UNITED STATES PATENT AND TRADEMARK OFFICE

APPLICATION NO.	FILING DATE	FIRST NAMED INVENTOR	ATTORNEY DOCKET NO.	CONFIRMATION NO.
10/663,757	09/17/2003	Eiji Hayashi	Q77556	3827

Office Action Summary

DETAILED ACTION

Fig. 3

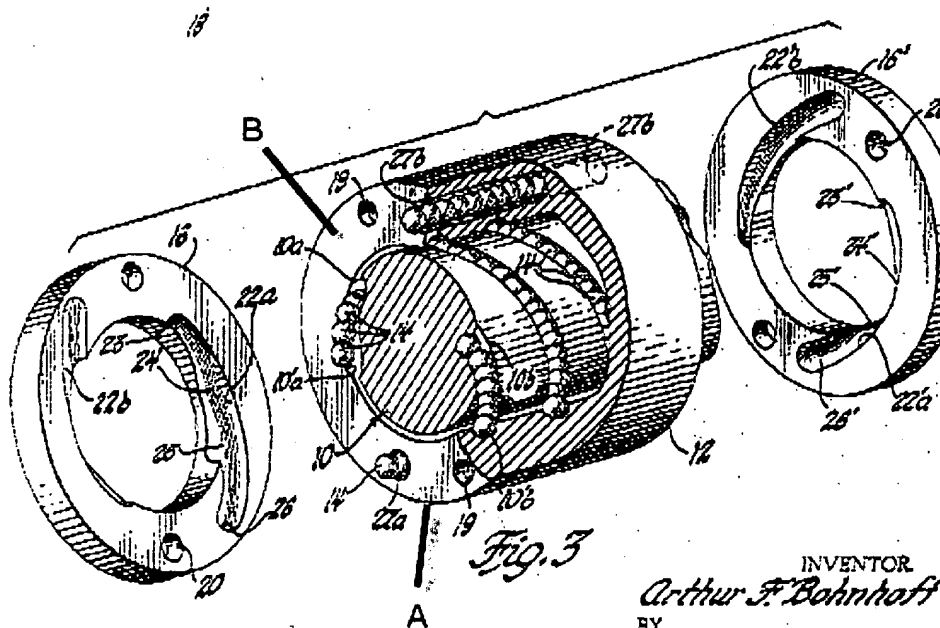
- Two screw grooves are respectively formed as multiple thread screws (10a,10b) and one of the side caps (16) is disposed on each of the multiple threads (10a, 10b see figs 2 and 3).
- Wherein the side cap (16) further comprises a pair of ball scooping up portions (see ball circulation passage, both sides, at 23) and a cap main body (16)
- Wherein the nut further comprises an axial end surface (see figure 3 below (B)), and the circumferential outer surface is a cylindrical surface extending perpendicular to the axial end surface.

3. Third, claim 2 sets forth that the nut comprises an axial end face, and a cylindrical outer circumferential surface extending perpendicular to the axial end face. Further, claim 2 sets forth that the side cap is disposed on that cylindrical outer circumferential surface. In contrast to that set forth in claim 2, Bohnhoff discloses a cap 16 mounted on the axial end face of the nut. Because claim 2 sets forth both an axial end face and a cylindrical outer circumferential surface, the Examiner's previous interpretation of Bohnhoff's axial end surface as the outer circumferential surface is now not appropriate.

4. Fourth, claim 15 sets forth at least one side cap including a ball circulation passage substantially extending in a longitudinal direction of the screw shaft. In contrast to that set forth in claim 15, Bohnhoff discloses ball circulation passages 22a, 22b that extend in a direction perpendicular to the longitudinal direction of the screw shaft.

- a. In response, Claims 1, 2, 4, 16, and 19 have been withdrawn as being drawn to a non-elected species. Furthermore, a marked up copy of figure 3 has been included which more clearly points out an axial end face (A) and a circumferential surface (B)

- a. In response, the examiner notes that Bohnhoff clearly discloses a ball circulation passage that extends in a longitudinal direction of the screw shaft (C3/L1-30). The balls are clearly shown extending from the nut into the side cap, thus the ball circulation passage extends in a longitudinal direction of the screw shaft as claimed.
